**Title: QUALITY AUDIT  
INCLUDING ROAD SAFETY AUDIT (Stage 1)  
For;  
Proposed Residential Development and Road Upgrade,  
Boherboy, Saggart, Co. Dublin.**

**Client: Pinnacle Consulting Engineers.**

**Report reference: 1151R01**

**VERSION: FINAL (February 2022)**

Drawing p200107X-PIN-XX-Dr-D-0011-SI Rev P01

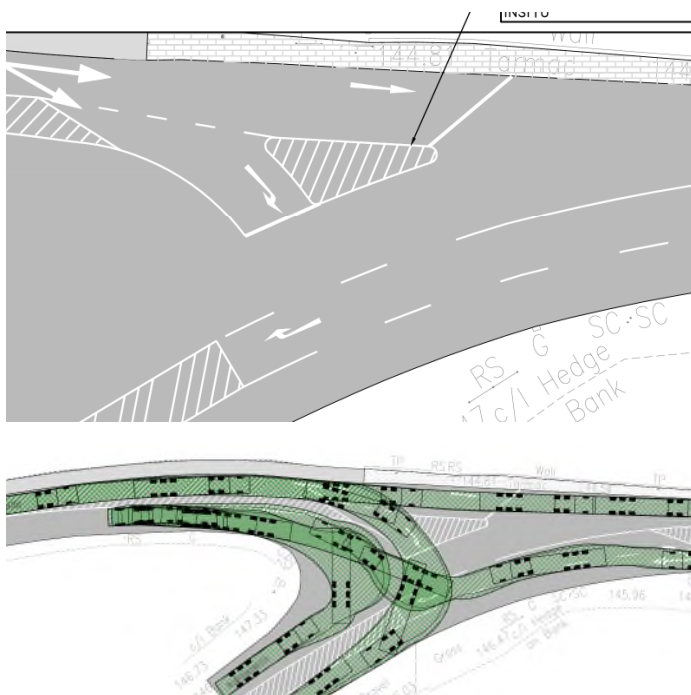
There is a risk of overshoot of the stop line at the N81 junction for eastbound drivers on Boherboy Road. This could lead to rear end or side-impact collisions with eastbound traffic on the N81. In addition the proposed straight ahead arrow may suggest drivers have priority to proceed.

It is recommended that a buildout be provided at the existing footpath into which some signage or other feature be provided to alert drivers that it is not a through route and which will force drivers to approach the N81 at a less acute angle. The straight ahead arrow should be removed.

Drawing p200107X-PIN-XX-Dr-D-0011-SI Rev P01, Boherboy Road, Chainage 740

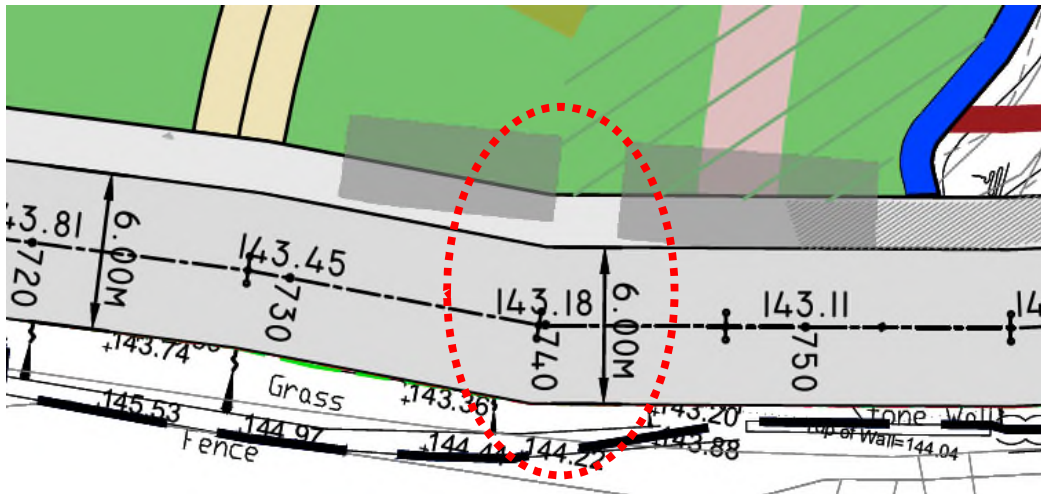
There is a 'kink' in the horizontal alignment of Boherboy Road at chainage 740. This could lead to overrun of the centre line and side-swipe collisions.

Ensure there is a smooth horizontal alignment with a series of curves of suitable radii be provided without straight sections joining.

Drawing p200107X-PIN-XX-Dr-D-0011-SI Rev P01, Boherboy Road, Chainage 70 to chainage 440.

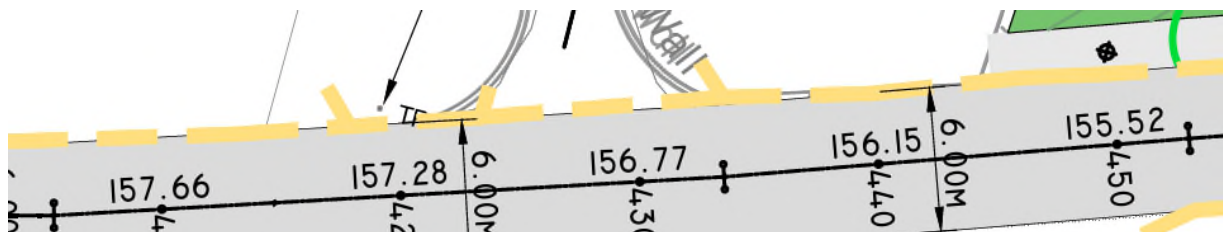
There is a discontinuity in the footway provision on Boherboy Road between chainage 70 and Chainage 440 due to land ownership constraints. The road is being realigned and widened to have a constant cross sectional width of 6m. There is a risk that the proposed development will lead to an increased usage of Boherboy Road by pedestrians wishing to travel to Saggart village, leading to a higher likelihood of a collision with vehicular traffic. It is proposed to provide a raised rib line along the section without a footway. There is a risk that the raised rib line will not be provided due to the noise effects on local residents.

It is recommended that the carriageway be marked narrower than 6m and that the verge be provided flat and level with the carriageway so that pedestrians will have refuge. In areas of wider road bed, vegetation should be cleared to provide additional refuge.

Drawing p200107X-PIN-XX-Dr-D-0032-SI Rev P01, Corbally Heath

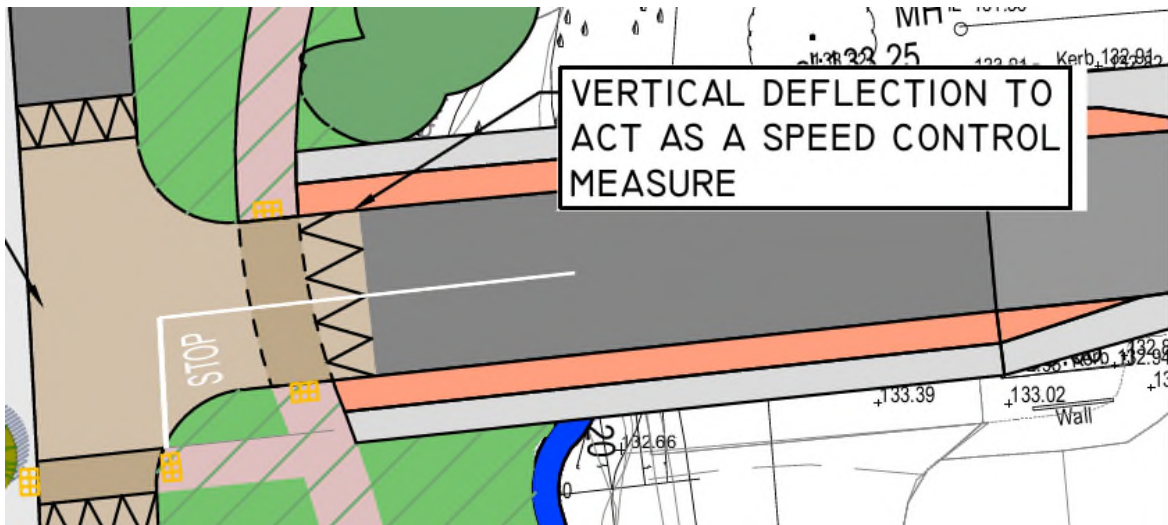
It is proposed to provide a shorth length of cycle track at the connection to Corbally Heath. There are no dedicated cycle facilities either side of this short section. This could lead to cyclists weaving into and out of traffic and sharing space with pedestrians that are not wide enough for both users.

It is recommended that the short section of cycle track be omitted.

Drawing p200107X-PIN-XX-Dr-D-0032-SI Rev P01, Corbally Heath

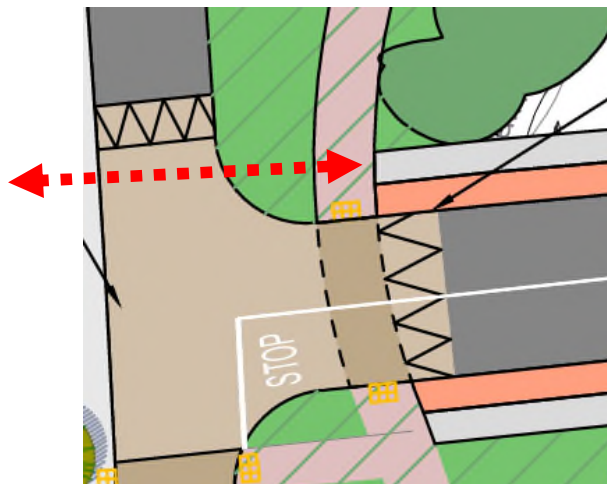
There will be a pedestrian desire line from the footpath on the northern side of Corbally Heath to the footpath on the opposite side of the internal development road.

It is recommended that a pedestrian crossing similar to the south side of the junction be provided.

Drawing p200107X-PIN-XX-Dr-D-0033-SI Rev P01, Carraigmore.

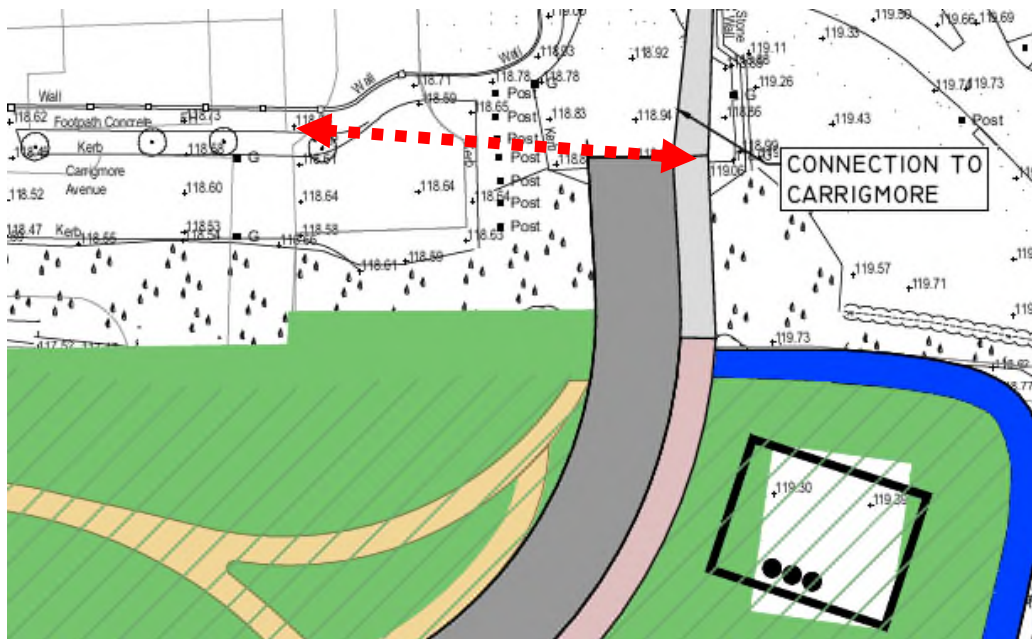
There is an existing pedestrian desire line from Carraigmore Green to Carraigmore Avenue. The demand will increase when the proposed development is fully occupied and this pedestrian desire line should be facilitated as an alternative pedestrian route to Saggart village rather than Boherboy Road.

It is recommended a pedestrian link to Carraigmore Avenue be provided.

Drawing p200107X-PIN-XX-Dr-D-0034-SI Rev P01, Culvert protection.

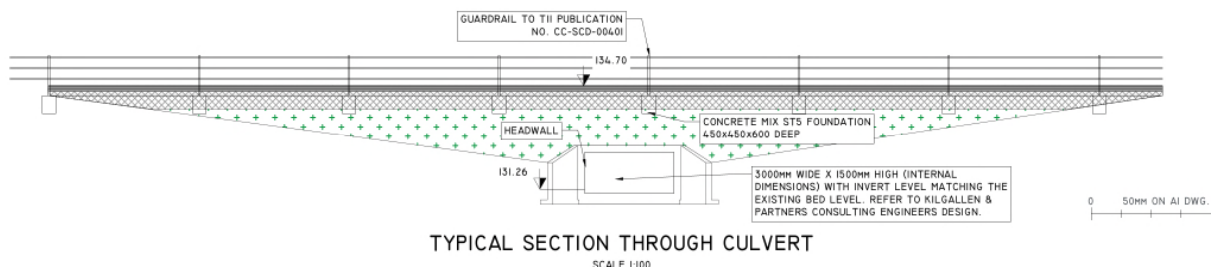
A railing in accordance with TII Standard Detail CC-SCD-00400 has been referred to on the drawing as containment at the bridge structures. It is unclear if this will provide adequate containment to errant vehicles.

It is recommended a risk assessment be carried out to ensure sufficient containment is being provided at the bridges/culverts.
